TVA-WBN-TS-00-11

**WATTS BAR NUCLEAR PLANT (WBN) UNIT 1 - TECHNICAL SPECIFICATION
(TS) CHANGE NO. 00-11 - "INCREASE IN DEGRADED VOLTAGE TIME DELAY"**

PROPOSED TECHNICAL SPECIFICATION (TS) CHANGE TS-00-11 DESCRIPTION AND EVALUATION OF THE PROPOSED CHANGE

FIGURE 1

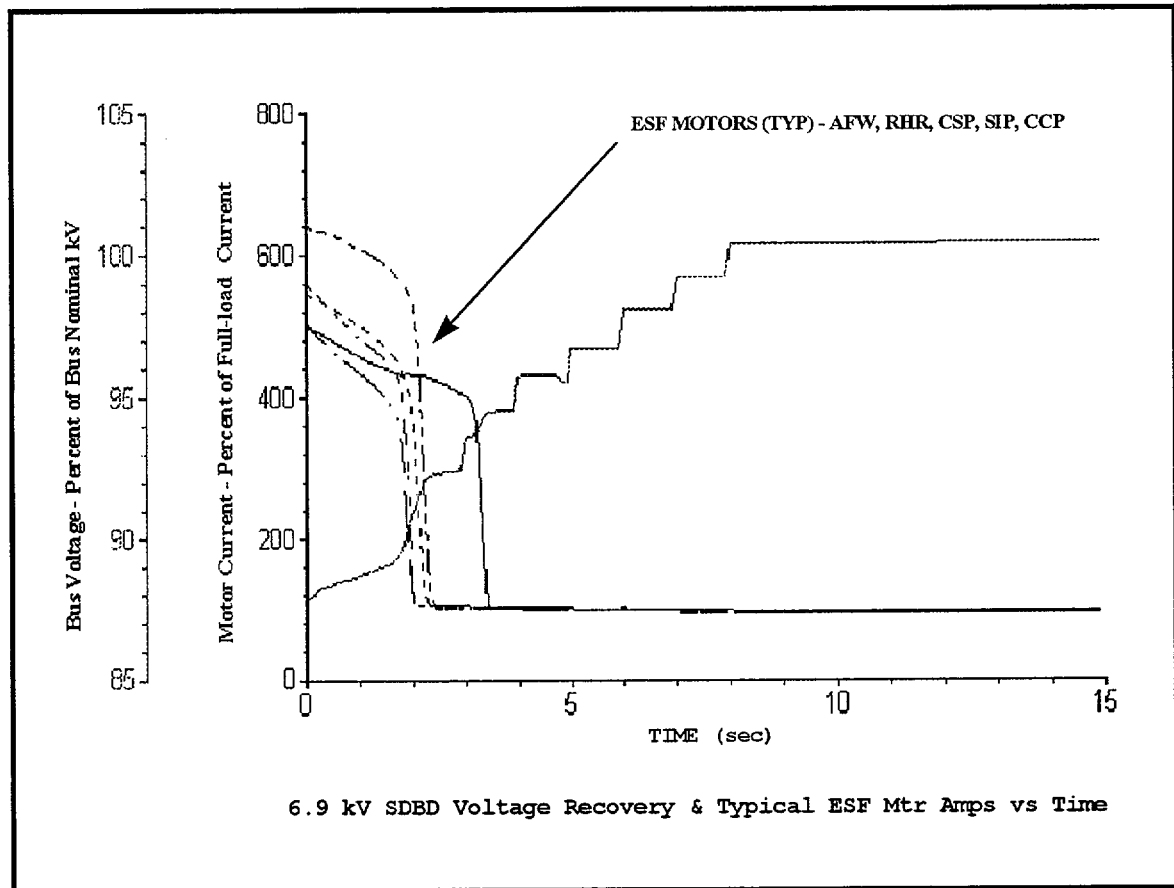
- ESF motors required to mitigate an accident will have sufficient voltage available at the terminals to ensure proper starting and operation, when supplied by offsite power. This includes achieving rated speed within five seconds after an SI initiation signal which simultaneously starts all ESF motors. Figure 1 below illustrates the composite response of the full load amperage for key ESF pump motors (auxiliary feedwater, residual heat removal, containment spray, safety injection, and centrifugal charging) plotted with a typical worst case 6.9 kV Shutdown Board voltage recovery profile based on plant calculations.
